ORACLE RIVERSIDE – PROPOSED SECURITY FENCING WORKS FIRE ENGINEERING REVIEW

JL9404/ap/03jll
25 March 2024

Figure 1 : Proposed Security Fencing Works

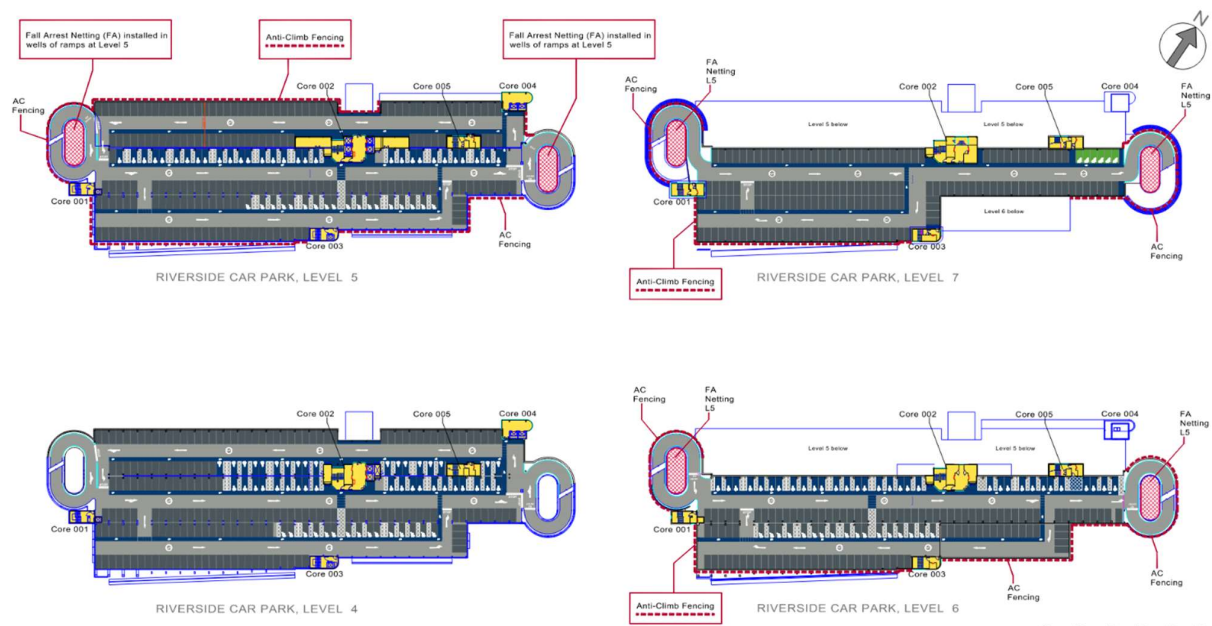
As noted in Figure 1, the proposed security works include anti-climb fencing and fall-arrest netting. It is proposed to use a Webnet system for both the anti-climb fencing and fall-arrest netting. The Webnet product is formed of 316 marine-grade stainless steel.

Fencing works are proposed to be provided to Levels 5, 6 and 7 as shown in Figure 1 above. Webnet security fencing will be fitted on top of, supported from or on the inside face of the existing parapet and structure of the car park.

The proposed Webnet security fencing system is fully non-combustible, as it is made of stainless steel. On this basis the proposal should have no impact on fire risk and the proposed material is compliant with current guidance.

Figure 2 : Stairs to the car park7

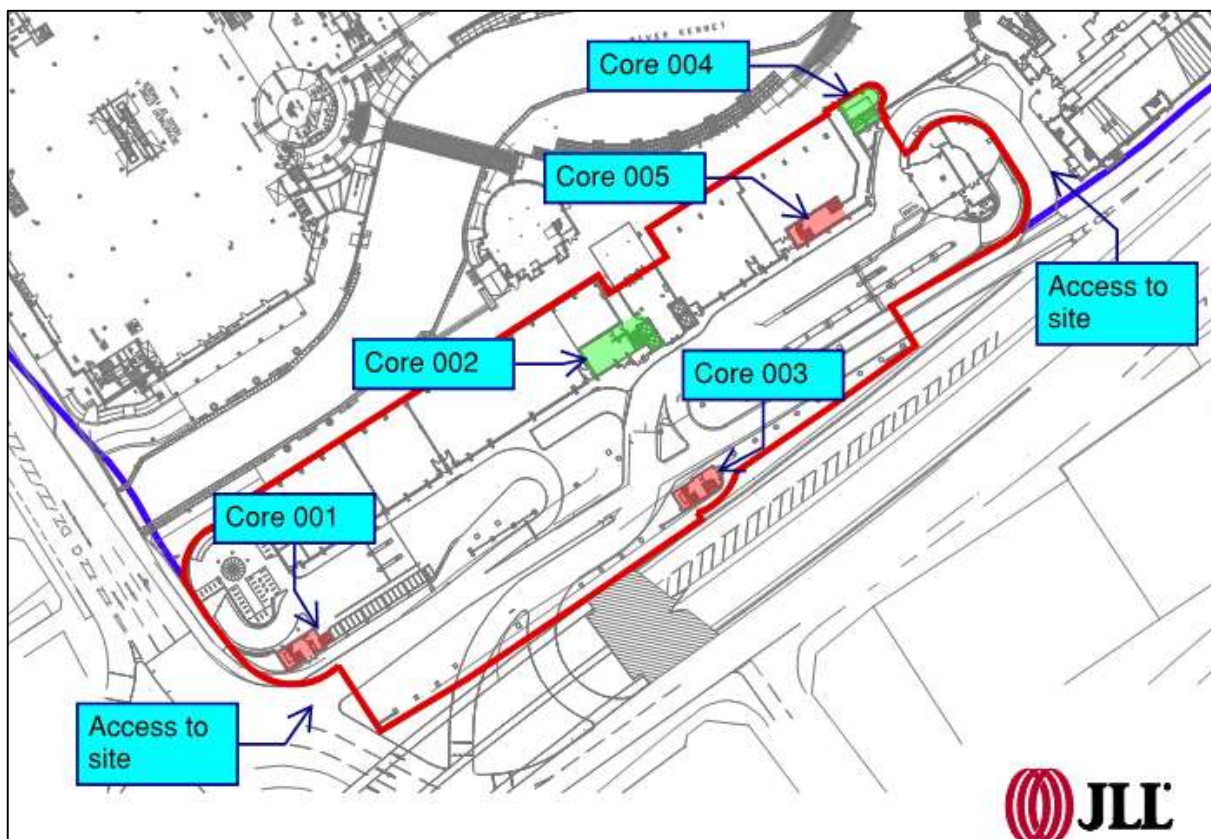
The proposal does not involve works that would have an impact on firefighting access and fire service access routes will be unchanged. The Figure below shows access to the site and locations of the stair cores of which Core 001, Core 003 and Core 005 are constructed as firefighting shafts.

The building is provided with firefighting shafts as existing to support firefighting operations from within the building. The firefighting shafts include firefighting lifts and dry fire mains. There is no expectation that firefighting at the levels concerned, which are quite high, would be from the external e.g. using high reach appliances. Therefore the proposed fencing work has no impact on firefighting facilities. As there are no changes in layout, hose coverage should remain as existing conditions.

Figure 3 : Level 7

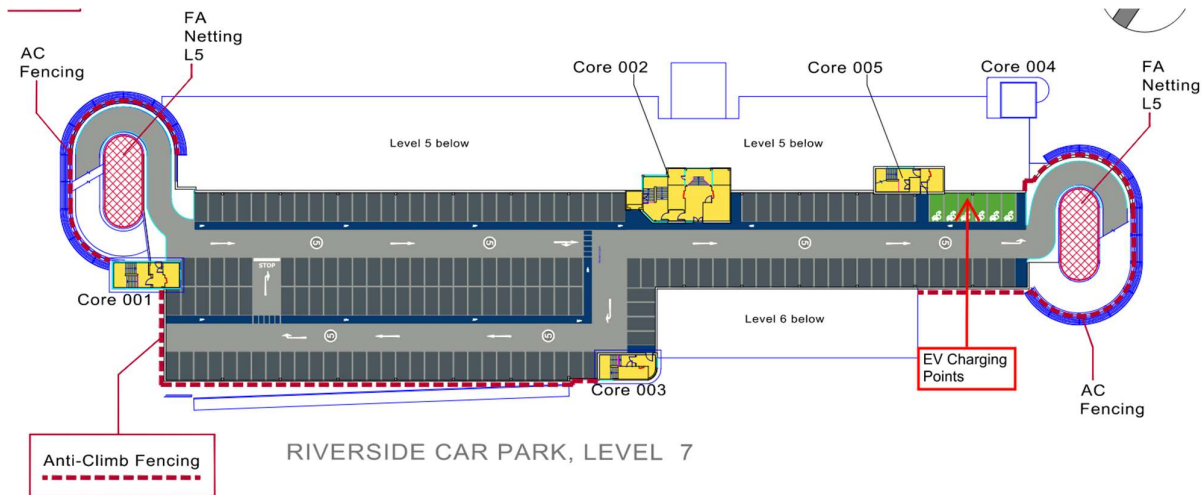
As existing, EV charging points are located at Level 7 as shown in Figure below.

There is no anti-climb fencing proposed to the EV charging point location, which means that there is no impact on existing conditions. In addition, Core 005 is a firefighting shaft which is in close proximity to the EV charging location. If a fire were sufficiently severe that firefighters chose not to use Core 005, Core 003 could be used as an alternative. The fact Level 7 is uncovered also offers an advantage to firefighters as there should be no build-up of heat and smoke. Therefore, firefighter access to the area housing EV chargers will remain adequate.
